# E5071B-15

# S E R V I C E N O T E

## E5071B ENA Series Network Analyzer, 300 kHz to 8.5 GHz

**When replacing A51 LCD, fasten the TORX T15 screws using a torque screwdriver (set to 1.02 N-m / 9.0 lb-in).**

e5070bae3014

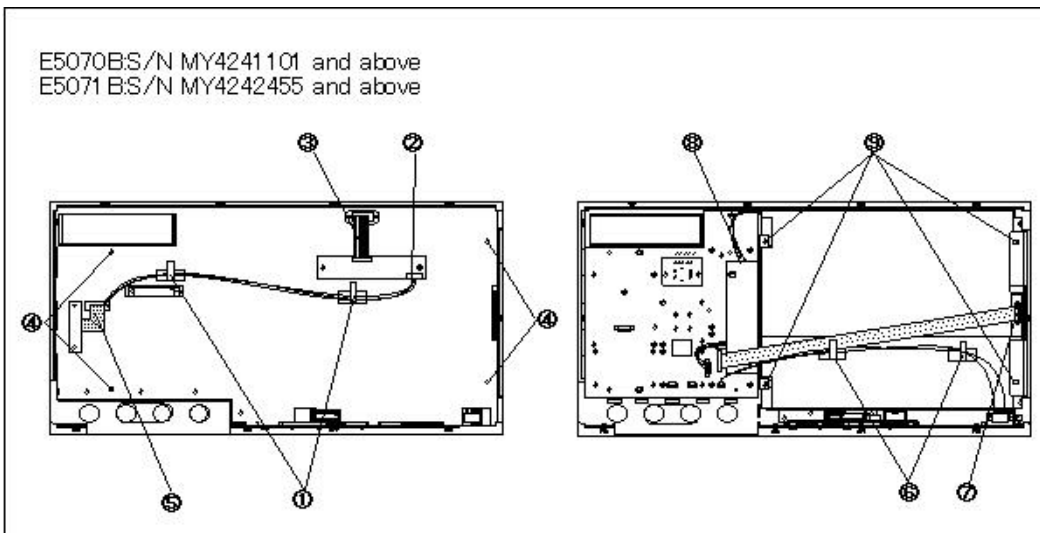
When replacing the A51 LCD, no torque info is shown in the service guide.

If you fasten the screw with over the appropriate torque, A51 LCD might be damaged, and if you fasten the screw with under the appropriate torque, LCD module might not be fixed against the vibration.

Fasten the TORX T15 screws (item 9) using a torque screwdriver (set to 1.02 N-m / 9.0 lb-in).
